CONSERVATION COMMISSION AGENDA

June 3, 2021

- 2. (7:05) DRAFT Mitigation Planting Guidelines initial review by the Commission
 - o Request: Discuss edits to Guidelines.
- 3. (7:15) 10 Cumberland Road cont'd NOI reconstruction of sunroom and garage with new deck on a single-family home DEP File #239-884

10 Cumberland Road

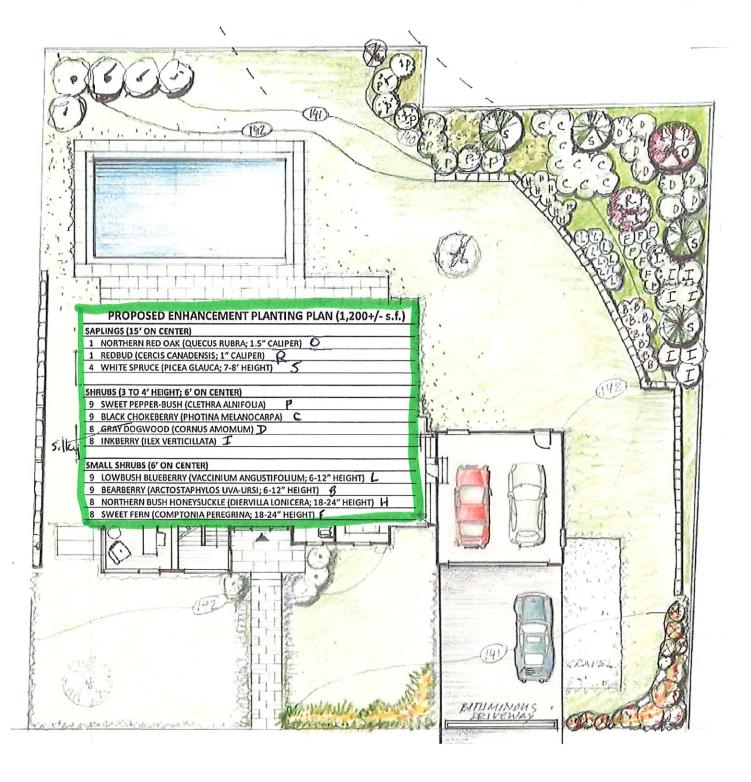
- The applicant should clarify access for the grading work in the rear yard.
- The applicant should provide a detail for the proposed footings for the deck.

- Staff feel that the nature and scale of proposed mitigation is appropriate and that the change in mitigation planting location is more appropriate than the previously proposed location; however, it appears to now be placed in an area where an existing fence is located. Applicant should clarify if the fence is proposed to be removed, or should provide revised plans showing the planting area free of any conflicts with existing structures.

- Should the Commission vote to approve the draft mitigation planting area guidelines, the proposed mitigation area should be reconfigured to be less linear.

- Staff Recommendations: If appropriate, vote to close the hearing and issue an Order of Conditions with the following special conditions.
 - Landscape plantings within Commission jurisdiction must:

- Compensatory flood storage must be provided in its entirety as per the plans, by removing 34 cubic feet of soil from under the proposed deck area.

PLANTING SCHEMATIC FOR ENHANCEMENT PLANTING AREAS 240 OLD FARM ROAD, NEWTON

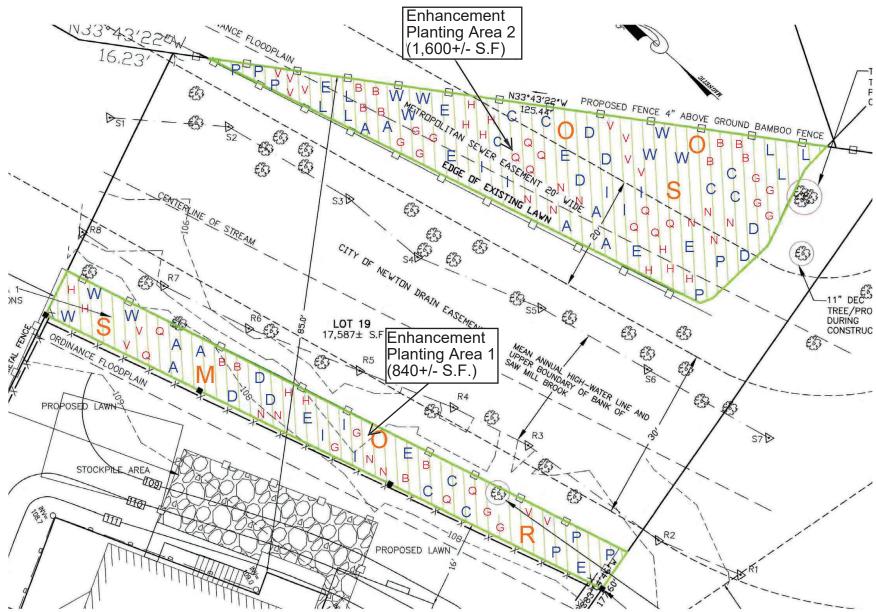
- The applicant proposes "enhancement" planting on the east side of the stream in what is currently lawn that is essentially an "encroachment" from the neighbor at 23 Marla Circle, as there is no access to that side of the stream from 240 Old Farm at the moment.

- Should the Commission vote to approve the mitigation planting area guidelines, enhancement area 1 presented for this project does not meet the sizing guidelines as it is only 8' wide.

- Applicant must clarify access for the restoration work on the east side of the stream (no method of access is shown on the plans or detailed in the notes).

- Applicant must clarify proposed fence removal and fence installation on the east side of the stream.
- Staff have concerns about the ability of the project team to save the tree currently in the chain link fence along the western edge of the stream. It seems like it will be damaged when the fence is removed.

- Staff have concerns about the proposed saplings chosen for the western planting area being in conflict with the
 existing canopy.
- Staff Recommendations: Await clarification from the applicant on the above questions.
